CITY OF KIRKLAND
Planning and Building Department
123 Fifth Avenue, Kirkland, WA 98033
425.587.3600 ~ www.kirklandwa.gov

MEMORANDUM

File No.: DRV23-00137

Subject: PARKSHORE JUANITA BAY PROJECT
DESIGN RESPONSE CONFERENCE

PARTIAL SOUTH ELEVATION - NTS

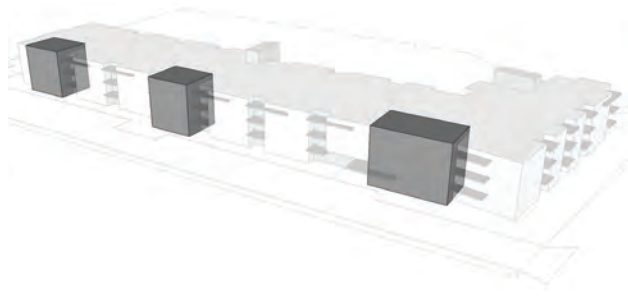
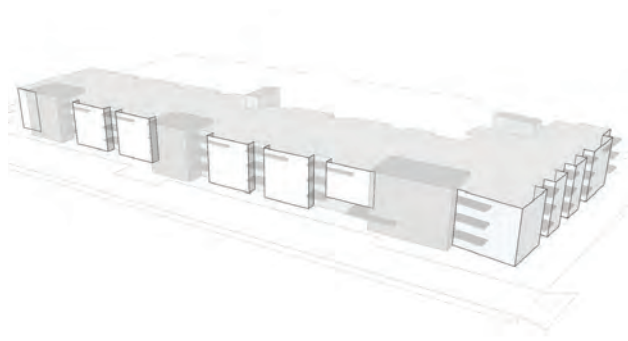
- *The applicant has refined the building massing along the south façade (see Attachment 2, pages 13-14) to incorporate varied window styles to differentiate first-floor common areas from the residential living units, unit balconies, and a defined building entry to create visual interest.*

* Provide a thoughtful design along south facade - most visible to pedestrians and surrounding developments (see pages 13,14)

The major articulation along the South public facing facade utilizes three brick clad volumes. Brick, as the primary cladding, provides a high quality building material with a textural human scale. The largest of these volumes is at the building entry corner and visible from 97th Ave NE as a way-finding element. The building signage is incorporated into a canopy that wraps around the first volume to provide weather protection for pedestrians, those at the drop off area and to signify the building entry, at the building entry and those at the drop off area.

Within the larger brick volume, windows are recessed vertically to add additional articulation and interest. This treatment is similar to that on other areas of the facade. Large windows are at the resident amenity areas to give a public face South to Juanita Beach Park.

The two additional brick volumes act as anchoring elements along the south facade length and break it up into smaller segment lengths.

EAST ELEVATION - NTS

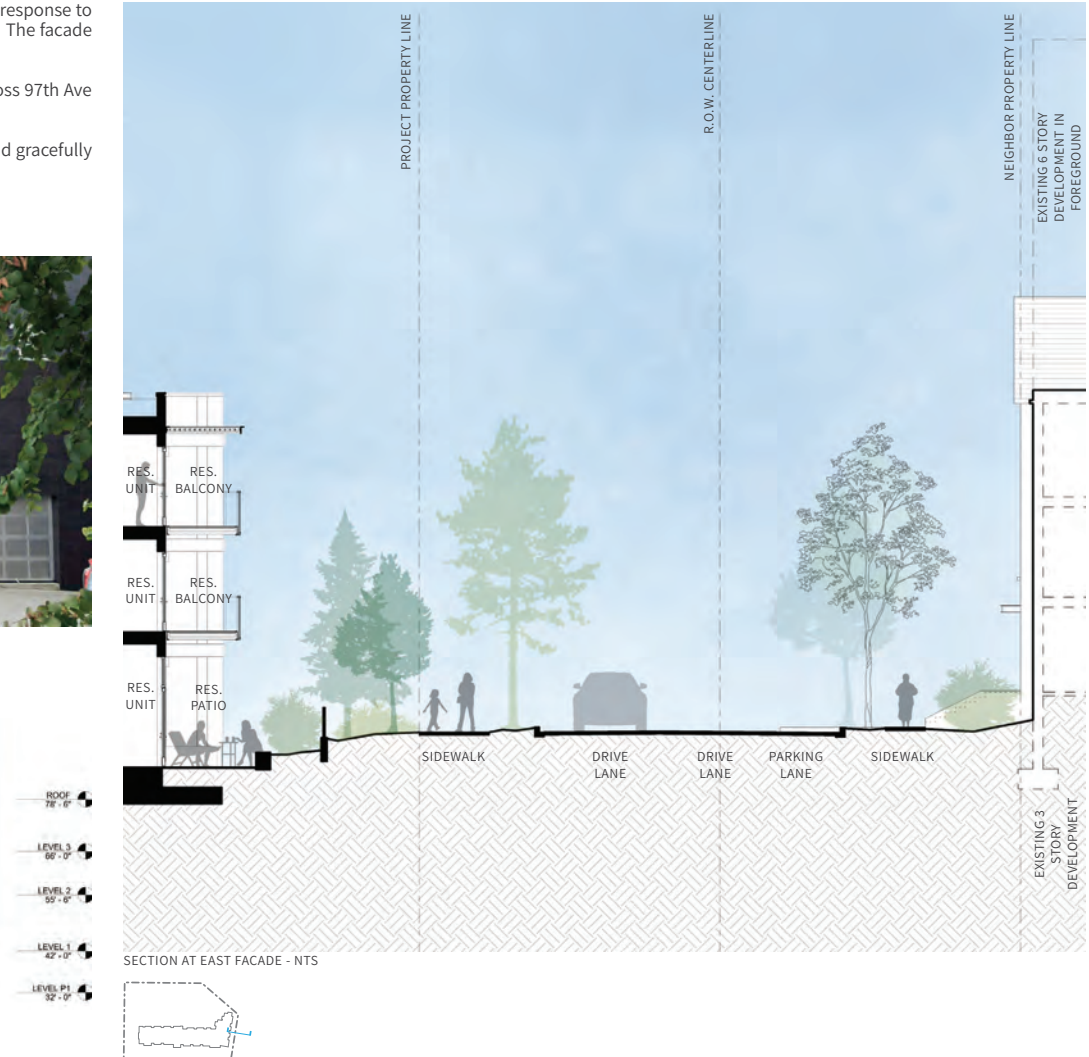
- *The façade along 97th Avenue NE has been designed to incorporate articulation with a residential scale to coordinate with the adjacent with*

The shorter east facade along 97th Ave NE incorporates a simpler articulation and more residential scale. This is in response to the Board comments at the Concept Design Conference and to be in keeping with the adjacent residential context. The facade language is similar to the secondary bay articulation shown on the south facade and elsewhere on the building.

The verticality of the units and bays has a scale and articulation similar to that of the townhouse development across 97th Ave NE.

The building setback from the property line provides space for the sidewalk and street improvements along 97th and gracefully addresses the grade change from the street level to the building floor level.
